J&T Consulting, Inc.

January 30, 2024

RE: Adequacy Review #3; Technical Revision (TR9); NCCI Pit #1 – File No. M-2001-107

Figure 1.1

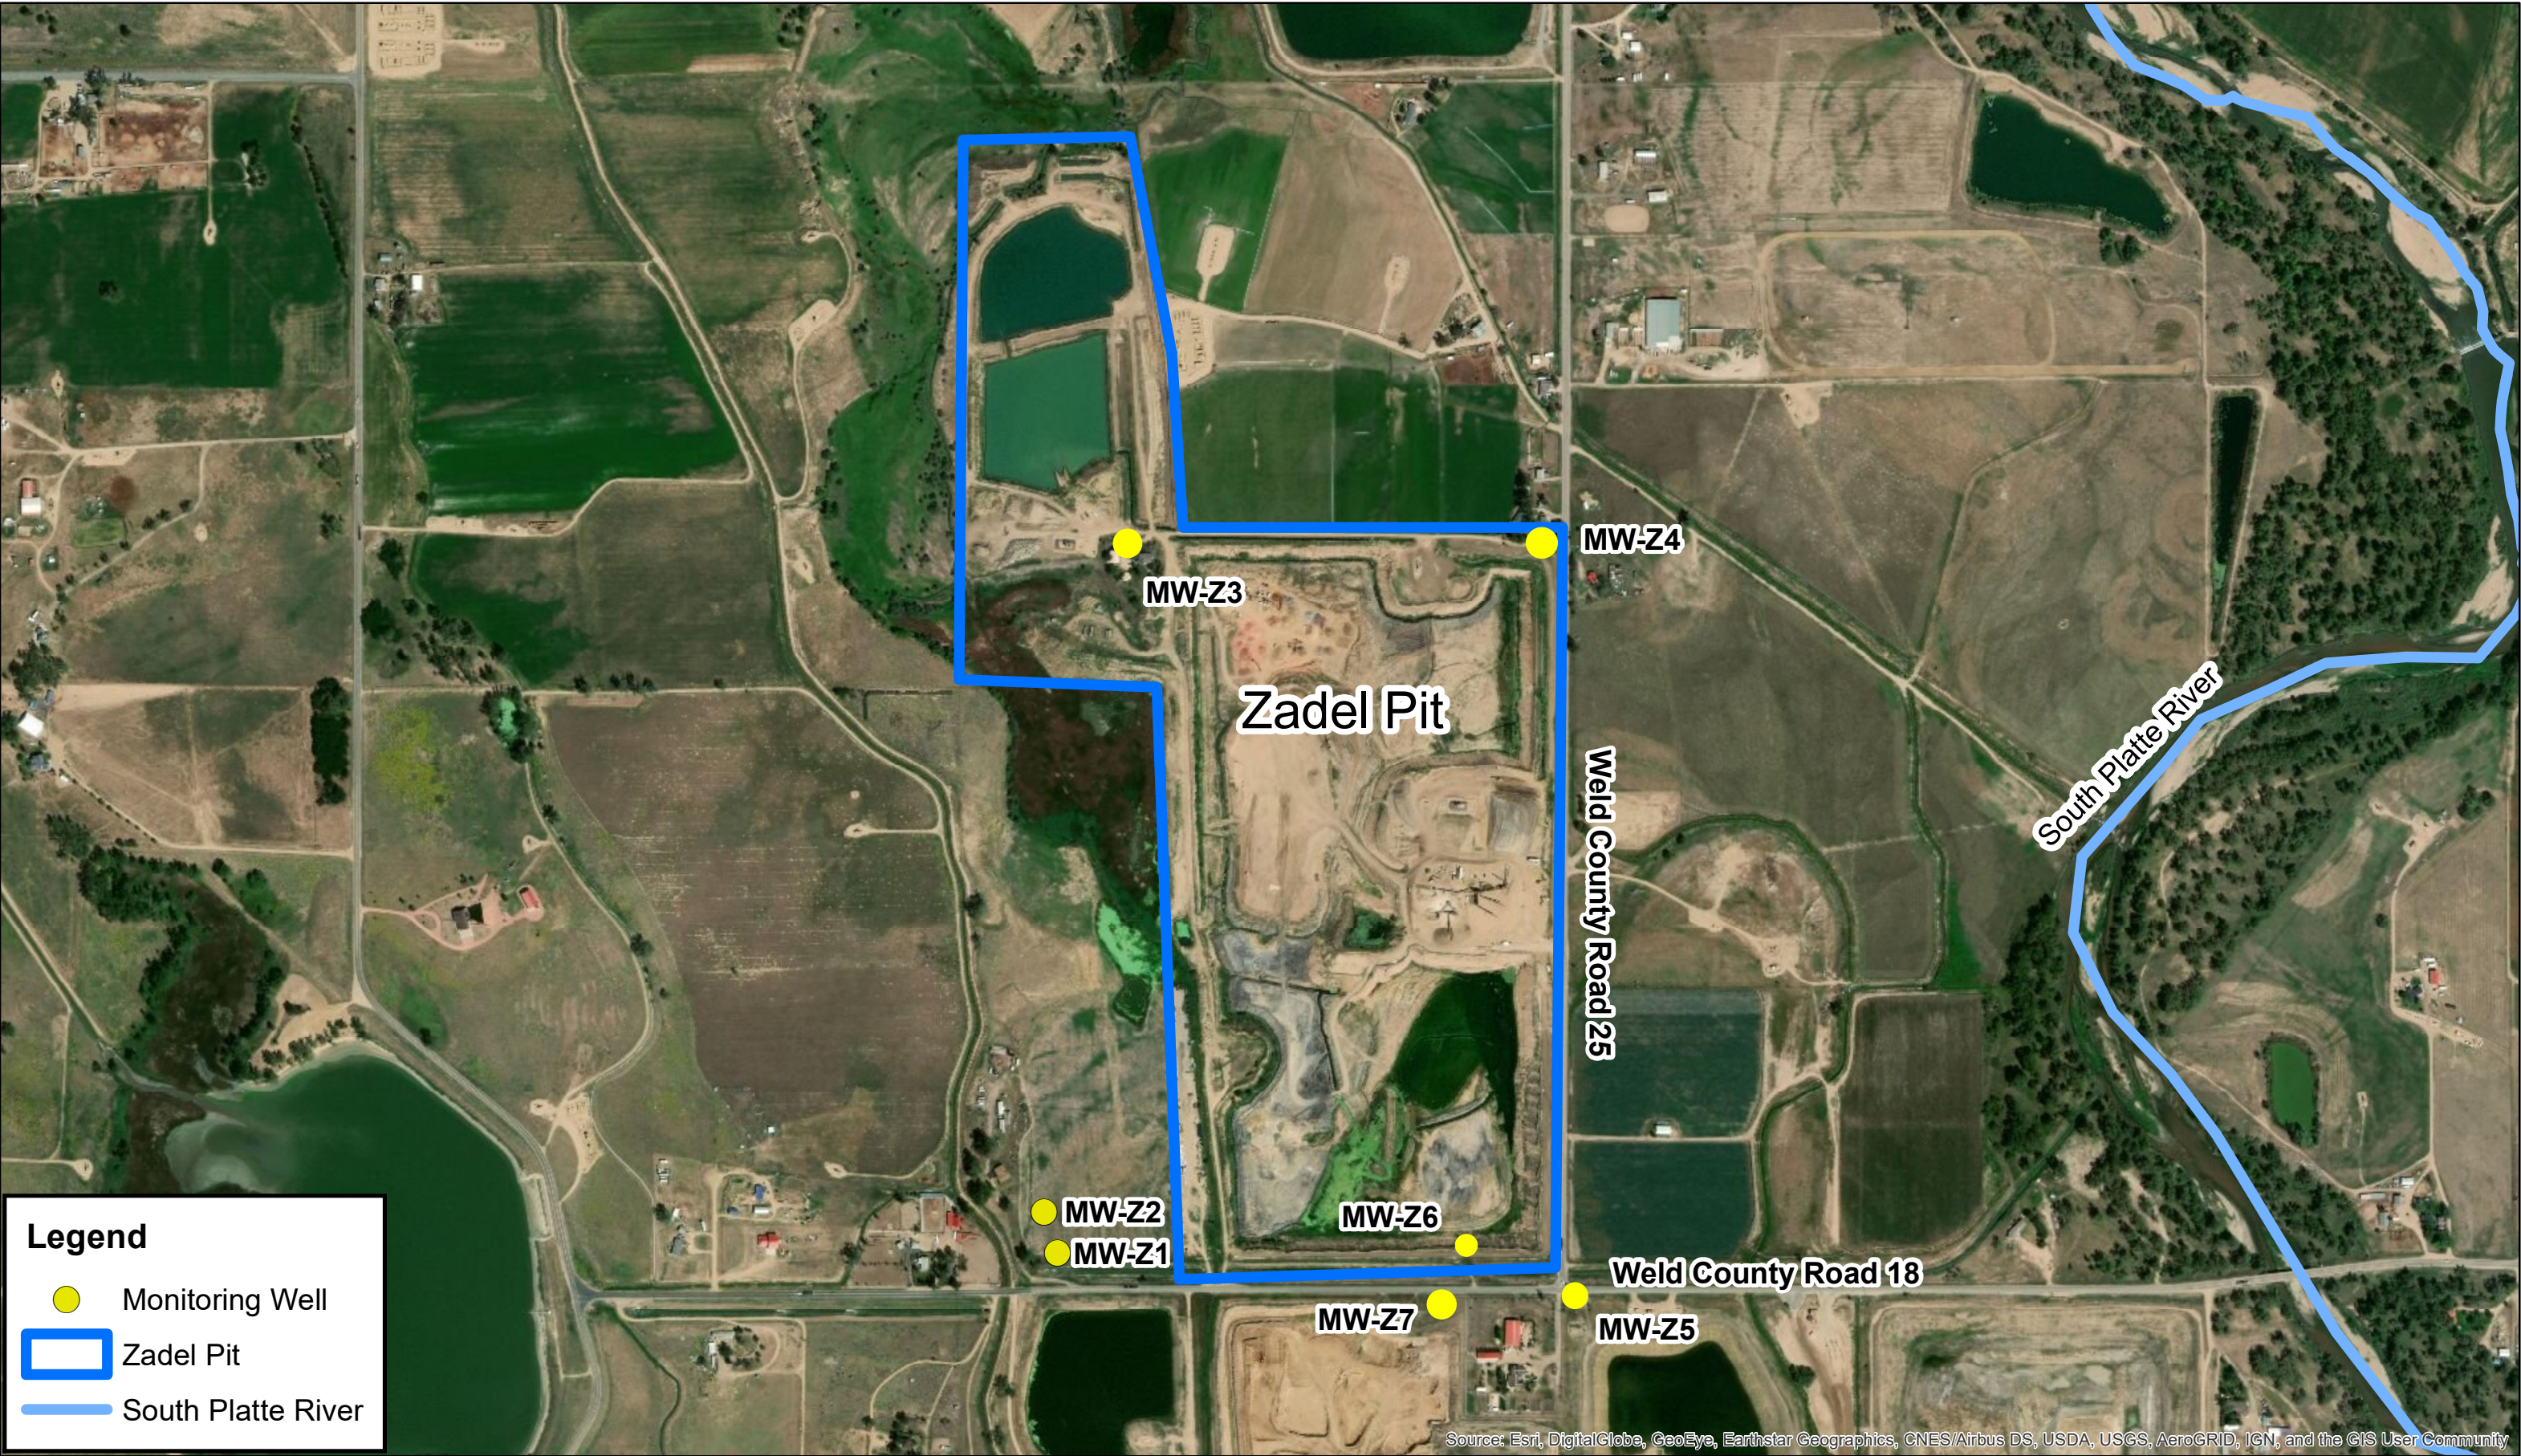
Additional explanation is needed to account for the groundwater level fluctuations seen in other wells across the permit, e.g. MW-Z3, -Z4, and -Z5. These wells also have also large

It appears that MW-Z3 may be influenced by leakage from LDC more than other wells, please comment?

The graph that compares MW-4 and -5 to MW-Z5 and -Z6 should be updated to include the water levels from MW-Z7. From the map provided it appears -Z7 is closer to MW-5 and MW-4 is closest to MW-Z5 while MW-Z6 is between wells -Z4 and -Z5.

Response: We have provided updated monitor well readings for the MW-Z1 through MW-Z7 to include the monthly readings. In our previous response we also indicated that there is also leakage from LDC and not just the LBD. Another reason there have been large fluctuations in the last couple years are due to the completion of the clay liner for the south cell for water storage. NCC is proposing to install a drain on the west side of LDC that will then cross under LDC and continue north to a location in the existing ditch that was previously used for dewatering where it can be daylighted and then flow back into LDC (See attached map with proposed location of the drain pipeline). Detailed design/construction drawings will be provided to the DRMS in the coming weeks and construction is proposed for the 2nd quarter of 2024, likely commencing in April 2024.

Response: We have provided updated monitor well readings for the MW-Z1 through MW-Z7 to include the most recent monthly readings.
